Subject: Oconee Nuclear Station
Docket Nos. 50-270
Additional Information Related to the NRC's
Interim Report on the Oconee Emergency Power
System

**Comments on the NRC Interim Report
for the Oconee Emergency Electrical System**

Figure 1

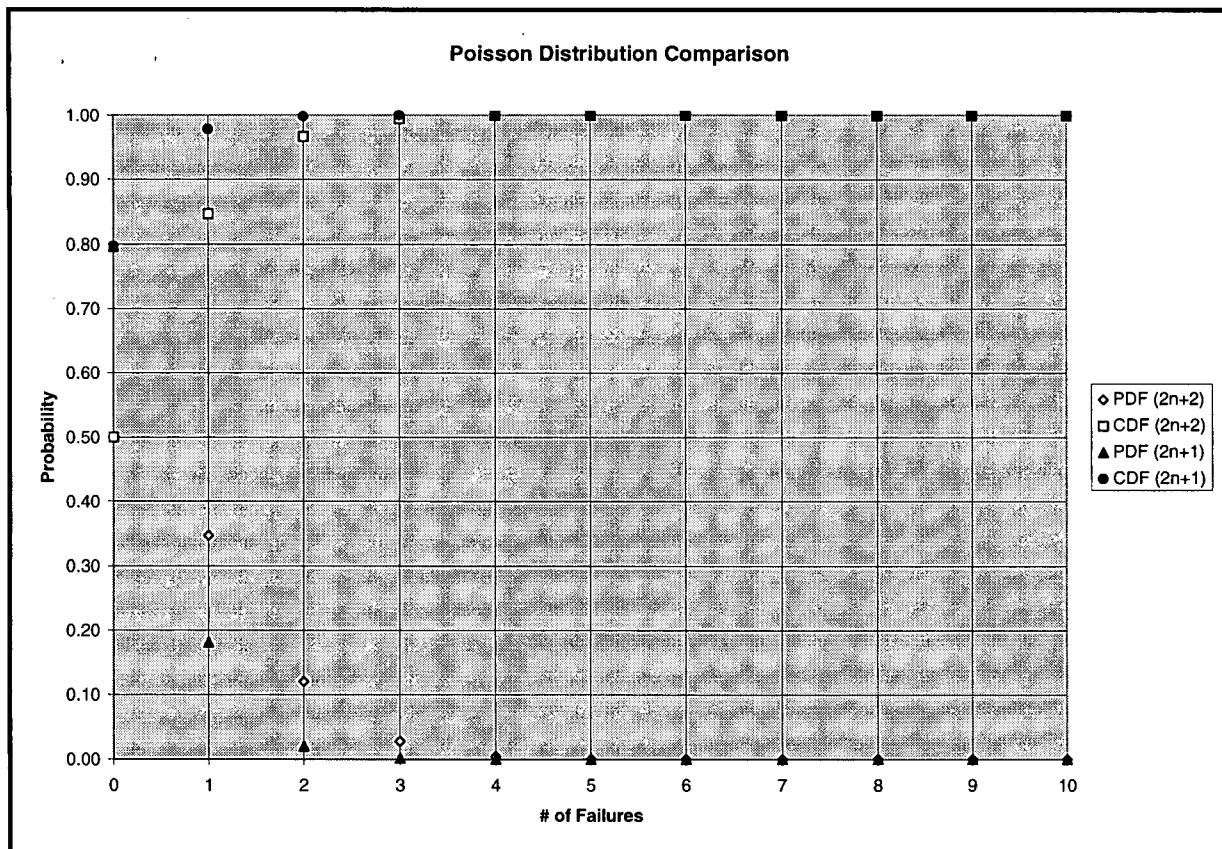
The method of estimation proposed by the Staff is derived from considerations for a conservative upper confidence limit of a Poisson distribution ($2n+2$ degrees of freedom for the upper confidence limit and $2n$ for the lower confidence limit). As such, it should be remembered that the confidence value is derived on the number of failures (a discrete random variable) not the failure rate. The most appropriate use for this limit seems to be as an estimator of the range on the number of failures in future observations of the process. To refer to the failure rate estimate derived from the upper confidence limit on the number of failures as a confidence limit on the failure rate is questionable. Figure 1 illustrates the probability density functions and the cumulative distribution functions for Poisson distributions based on failure rates calculated by the Staff's suggested method and the method used by Duke. As seen and as expected, if the actual failure rate is as estimated with the Staff's approach ($2n+2$ degrees of freedom), 50% of the samples contain 0 failures and 50% contain 1 or more failures. On the other hand, using Duke's approach ($2n+1$ degrees of freedom), 80% of the samples contain 0 failures and 20% contain 1 or more failures. Both results are reasonable and one is more conservative in characterizing the failure rate. To relate this concept to the specific components modeled in the Keowee PRA, it implies that with zero failures in the past 10 years, the Staff's suggested model would estimate a 50% chance of 0 failures in future observations (10 year periods) while the method used in the Keowee PRA would imply that there is an 80% likelihood of seeing 0 failures (20% chance of one or more failures). Both estimates are reasonable and one should not be characterized as incorrect.

Because distributions such as the Binomial and the Poisson are discrete, it is not possible to establish upper and lower confidence limits that provide exactly the confidence level desired. A desired condition for an upper confidence limit is $P(\lambda > \lambda_{\text{upper}}) = 0.05$ for all λ . The limit, like the random variable, can take on only integer values. The equality can not be made true for all possible values of λ . It is customary to adopt a conservative definition by requiring instead that $P(\lambda \geq \lambda_{\text{upper}}) \leq 0.05$. A similar inequality is established for the lower limit. As a result, limits for a 90% confidence interval, for example, actually provide "at least" 90% confidence. The upper and lower limits that result can be evaluated from chi-square distributions where the degrees of freedom for the upper and lower limits are $2n+2$ and $2n$ respectively. The upper and lower limits derived in this manner are for the Poisson random variable which is the number of observed failures. When these values are modified and applied as confidence intervals on the underlying failure rate (a continuous variable), the real meaning of these values is distorted. It is observed that as the confidence interval is shrunk (the upper and lower limits both approaching the median) the limits do not collapse to a single point due to the differing degrees of freedom. This residual

interval results from the discreteness of the original distribution and the inability to satisfy the equality in determining the confidence limits. The method used in the Keowee PRA selects a point within this interval by performing the median calculation using a degrees of freedom that is the average of the values for the upper and lower limits ($2n+1 = [2n+2 + 2n]/2$). This can be considered to be an approximate numerical correction for the discreteness of the data.
